Application for Licence Amendment

Licence Number	L6498/1991/11
Licence Holder	Northern Star Resources Ltd
ACN	092 832 892
File Number	DWERVT16194
Premises	Jundee Mining Operations Legal description Mining tenements G53/20, M53/191, M52/412, M53/413 and M53/414 As defined by the Premises maps attached to the issued works approval
Date of Report	25 November 2024
Decision	Revised licence granted

Figure 2: Elliot TN dewatering pipeline route

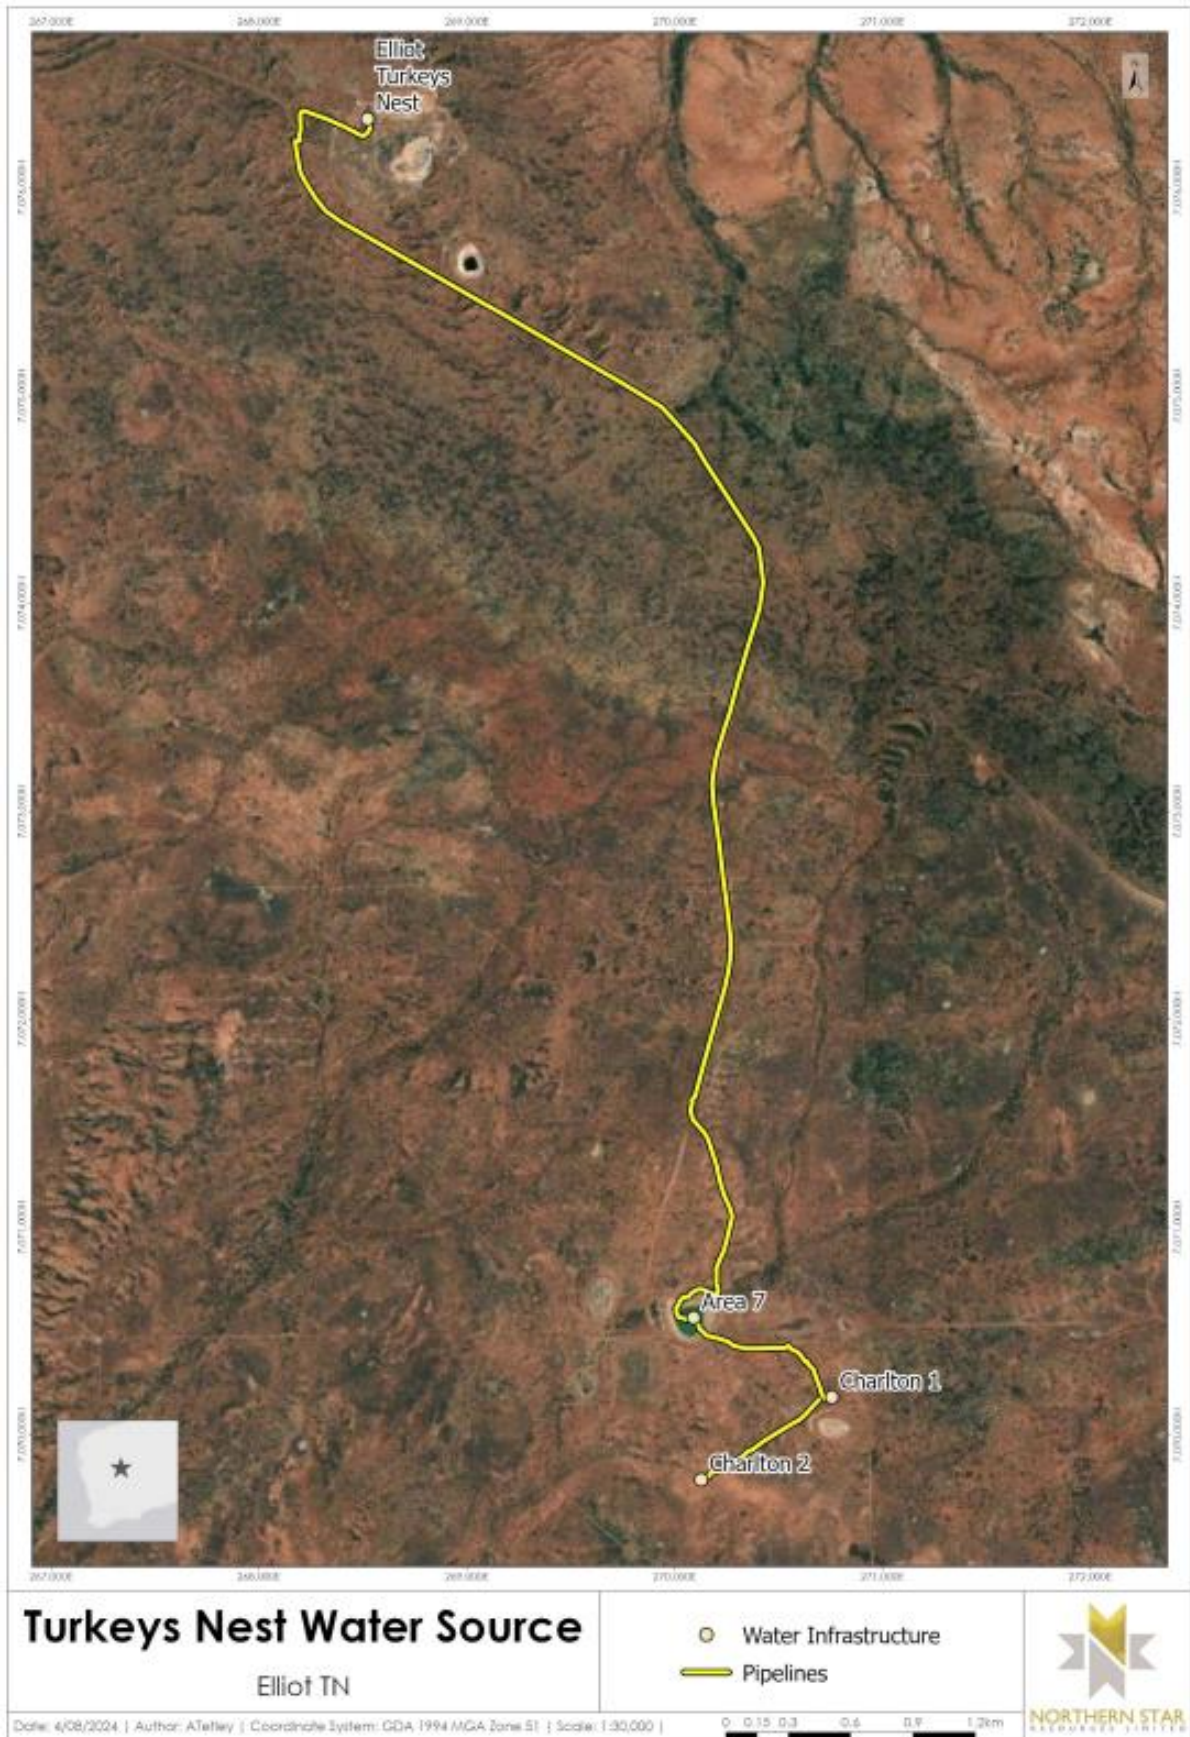
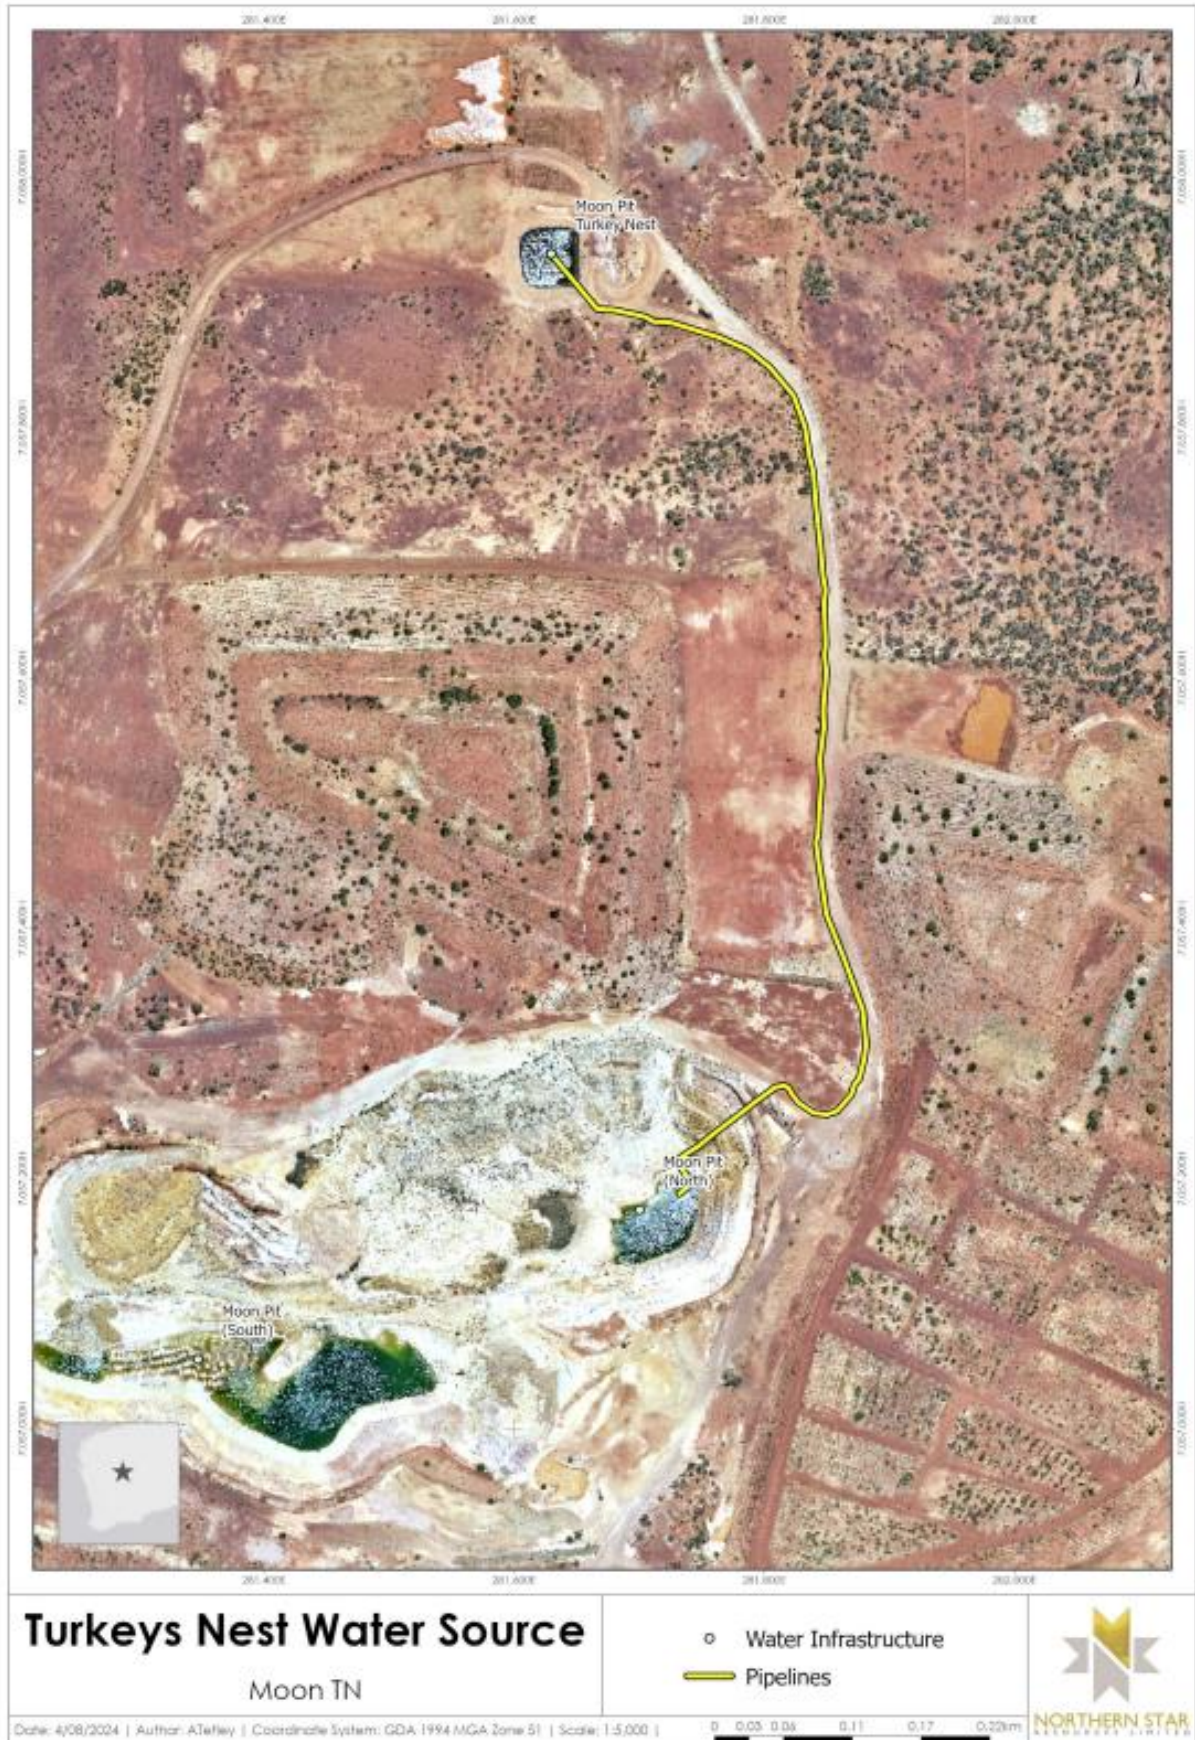
Condition	Summary of Licence Holder's comment	Department's response
Table 1.2.1	Maps for Figure 9 correspond to Figure 2: Elliott TN dewatering pipeline route and Figure 3: Moon Pit TN dewatering pipeline route found in L6498/1998/11 Amendment Report Draft:	Figure 3 from amendment report has been added to licence as new Figure 10 Figure 10 reference updated to Figure 11
Maps	New map showing location of landfills provided	New map inserted as Figure 11
	New map showing location of Fisher in-pit TSF monitoring bores provided	New map inserted as Figure 7
	Figure 9 is missing Moon Pit Turkey's Nest figure. L6498/1998/11 Amendment Report Draft: Figure 3: Moon Pit TN dewatering pipeline route, can be used.	Figure 3 from amendment report has been added to licence as new Figure 10
Condition 1.2.11 (d)	With regards to Gateway and Invicta Landfills, could the requirements set under 1.2.11 be applicable for the first trench only.	Yes, this is the intent of the condition. No changes to wording has been made.
